Fishermans Bend Standing Advisory Committee – Tranche 1B Report

**Port Phillip Planning Scheme draft Amendment
C163port
203-205 Normanby Road, South Melbourne (Site 6)**

13 May 2020

Figure 6 Architectural renderings from the corner of Montague Street and Normanby Road at 30, 32, 34 and 36 storeys

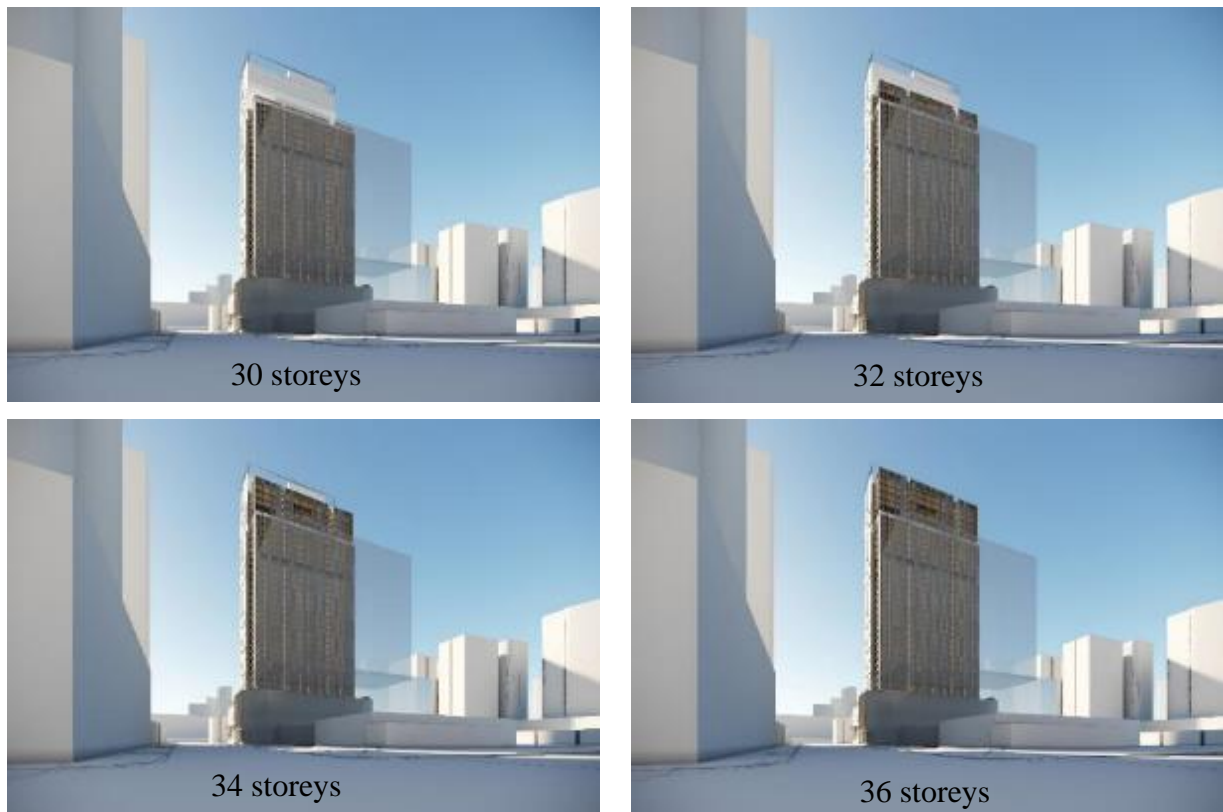
The Committee's analysis, assisted by the additional renderings and inspections, lead it to conclude that a 30 storey building will provide a more appropriate transition to the preferred '20 storey' maximum height in the DDO30, a more legible difference in height and improved volumetric relationship with the adjacent building and the potential to improve environmental impacts such as reducing overshadowing of the future linear park. There is also the prospect of increased daylight and outlook for future dwellings that may be constructed on land to the west (as discussed in Chapter 4.4 below).

Another consideration is that 30 storeys would reasonably screen the adjacent building, noting that screening existing buildings is not a key priority in the planning controls or policy when referencing preferred future character. In reaching this conclusion, the Committee found that the visual impacts of the blank wall will be largely mitigated by the separation distance and upward view lines from the key public realm viewpoints.

Include a condition in the Incorporated Document requiring amended plans to be submitted for approval by the Responsible Authority in consultation with the City of Port Phillip that reduce the building height to a maximum of 30 storeys (101 metres Australian Height Datum to the top of the lift overrun and façade).

Figure 9 Further Architectural Renderings – Podium

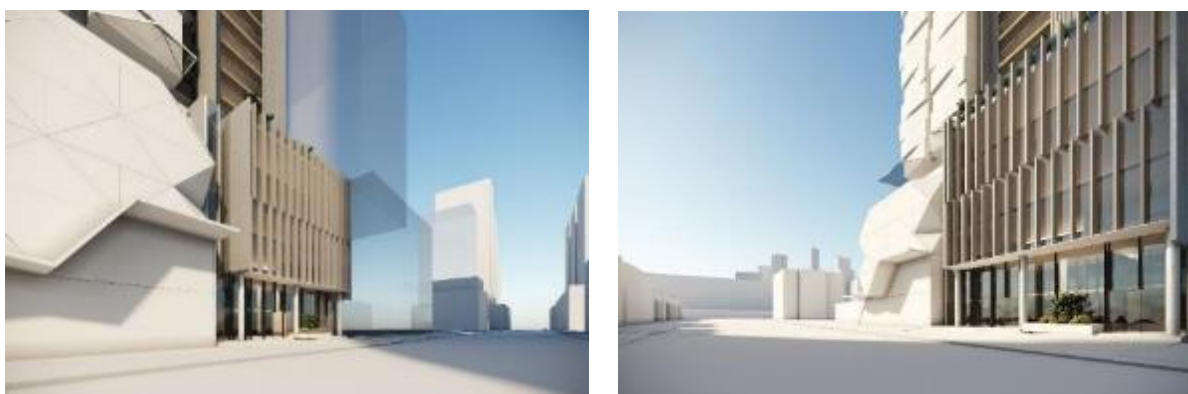
The Committee reviewed the additional renderings provided and supports the Taskforce’s concern about side-on views as seen in Figure 9 (Further Architectural Renderings – Podium). The Committee considers however that views in and out from various angles can be addressed in different ways and should correspond with the design concept for the building overall.

Figure 12 Site 6 - Section A-A, Drawing S06_A11.01

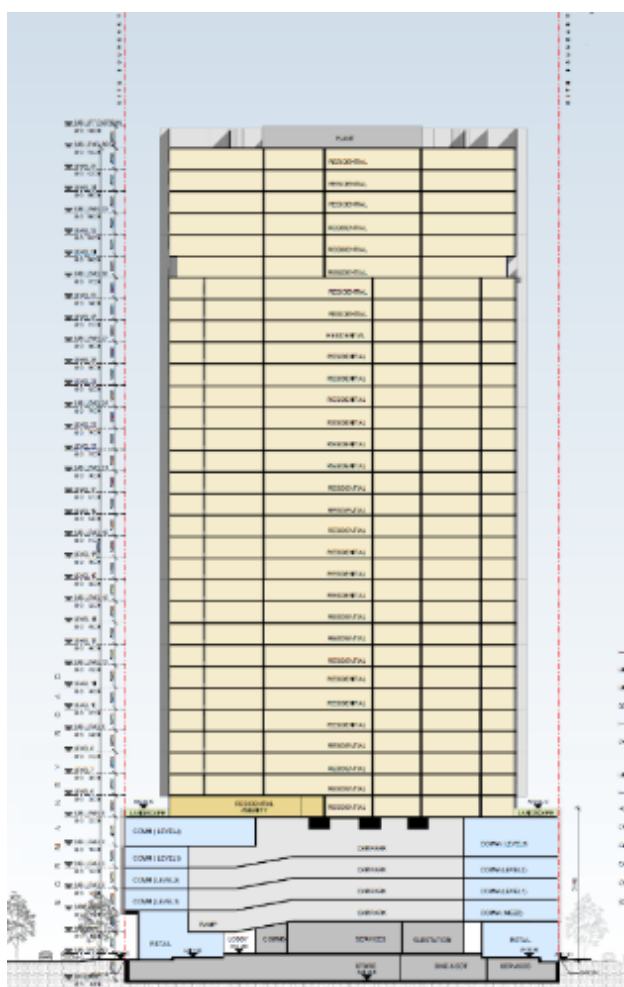
Levels 1, 2 and 3 as well as associated car parking levels are 3.0 metres in height floor to floor - short of the 3.8 metres sought by Table 9. This would provide less future adaptability to convert car parking into commercial tenancies.

Figure 13 Normanby Road access

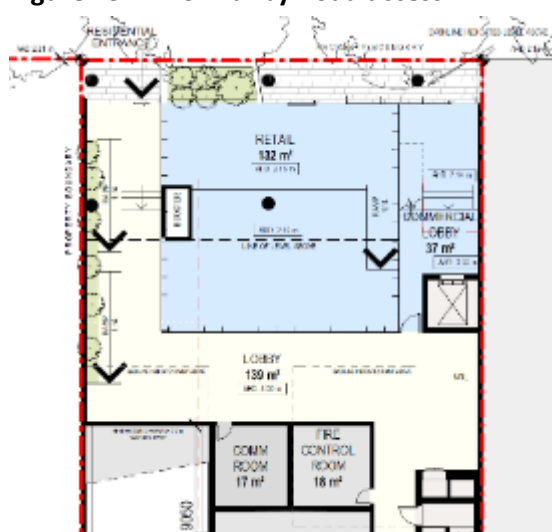
The Committee does not consider this arrangement best practice for equitable access as the path is too long and likely to rely heavily on signage for way finding.

Figure 14 Woodgate Street access

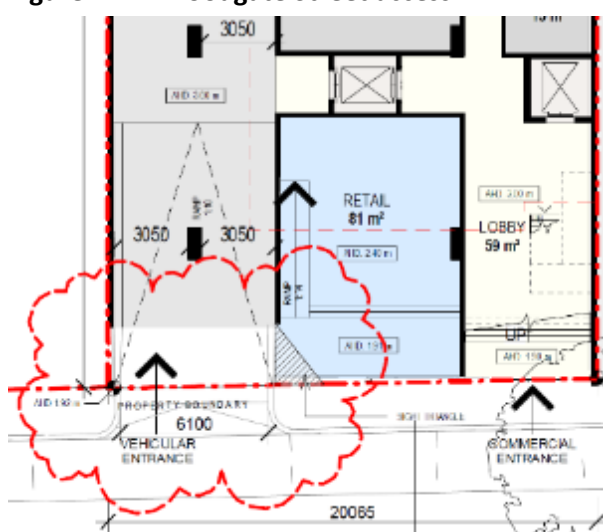
At the Woodgate Street entrance there does not appear to be any disabled access into the lobby at all. This would mean that a person who can't use stairs either can't access the south retail tenancy or Woodgate Street at all or would have to travel through the south central lift, down the car park ramp onto the footpath and back into the retail tenancy. As a last resort a person would have to travel even further via Normanby Road, Montague Street and Woodgate Street just to get to the back of the building or towards the future park, which – according to the Taskforce – is likely to be only in the order of one metre above Woodgate Street at this point.

The Committee is also concerned about the lack of a safe, ramped walkway to enter and exit the building and ground floor lift lobby for cyclists and the like next to the car park entrance and loading bay. It sees potential danger when, for example, parents and children with bicycles need to share the ramp with vehicles, wait for the lift to the basement, while others may need to exit the lift and cars or trucks may enter or exit the building. Exiting the lift lobby to enter the ramp appears even more potentially hazardous.
